GMN is introducing the tolerance class P4+. This tolerance alleviates the need for any additional; high marking, grading, or matching. This is a direct cost savings to your bottom line! The P4+ is being phased in through 2016 into 2017 across the entire super precision angular contact bearing range.

PN = HYS 6006 ETA P4+ UL

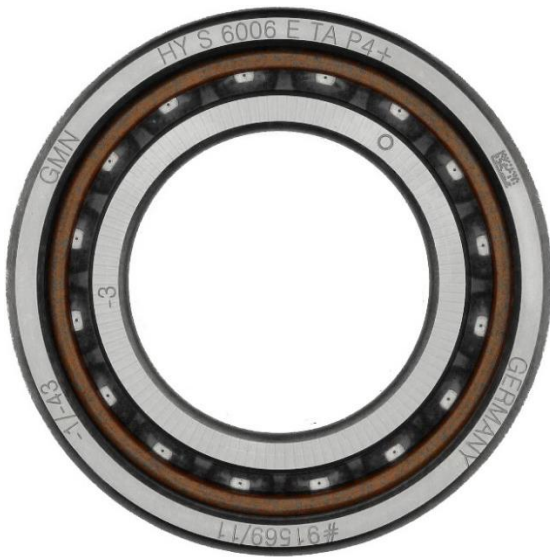
The same quality you expect from GMN will continue, but with additional tolerancing printed right on each bearing box and each bearing. ID, OD, and width deviations are all present along with an inner race high point mark. Please see the examples below and feel free to contact GMN USA with any questions.

ID = -3 microns below nominal

OD = -1 micron below nominal

Width = -43 microns below nominal

IR High Point = ~1 O'clock within example

T274 = Lubcon L252 Grease
